Access Compliance Report

Public Rights-of-Way

(Curb Ramps)

Intersection ID: 10033982	Main Street: PARK_RD	Cross Street: N/A	Location: NW
ADA ID: F910B0DD636C	Ramp Type: PerpDiag	Initial Pass/Fail: Fail	Overall Compliance: No
		Severity Score: 12.5

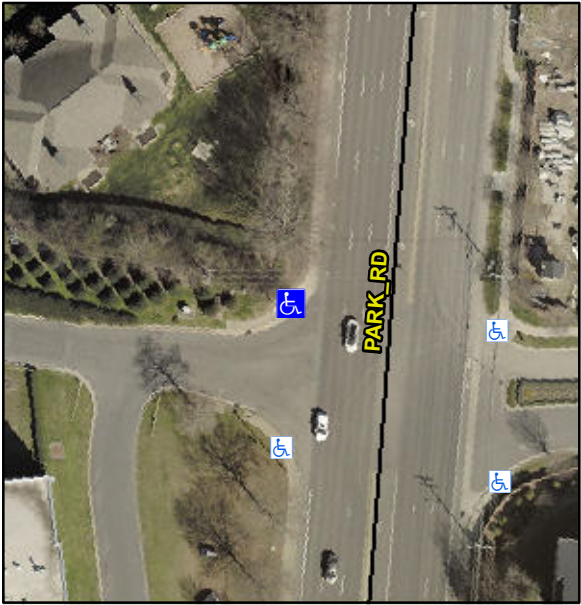
Codes/Mitigation Info/Possible Solution			Field Measurements/Component Compliance			
	Possible Solutions:		Compliance	Description	Data	
	Remove & Replace Curb Ramp With Two New Directional Ramps or Equivalent.		N/A	Ramp Length (in)	60.0	No
			Yes	Ramp Width (in)	56.0	Yes
			N/A	Flare Type LT	N/A	N/A
			N/A	Flare Slope LT (%)	N/A	N/A
			N/A	Flare Traversable LT?	N/A	N/A
			N/A	Landing Length (in)	N/A	N/A
			N/A	Landing Width (in)	N/A	N/A
			N/A	Landing Slope (%)	N/A	N/A
			N/A	Landing X Slope (%)	N/A	N/A
			N/A	Landing Curb? (Y/N)	N/A	N/A
			N/A	Shared Landing?	N/A	
			N/A	Gutter Ponding?	N/A	N/A
			N/A	Gutter Lip Ht (in)	N/A	N/A
			N/A	Painted X Walk1?	No	N/A
				X Walk 1 Direction	To SW	X Walk 2 Direction
			N/A	X Walk 1 Width (in)	N/A	N/A
				X Walk 1 Slope (%)	2.7	X Walk 2 Slope (%)
				X Walk 1 X Slope (%)	2.0	X Walk 2 X Slope (%)
			N/A	Ramp inside XWalk1?	N/A	N/A
<p>Surveyor Notes:</p> <p>N/A</p> <p>PROW/ADA:</p> <p>Not Found, R304.2.2</p>
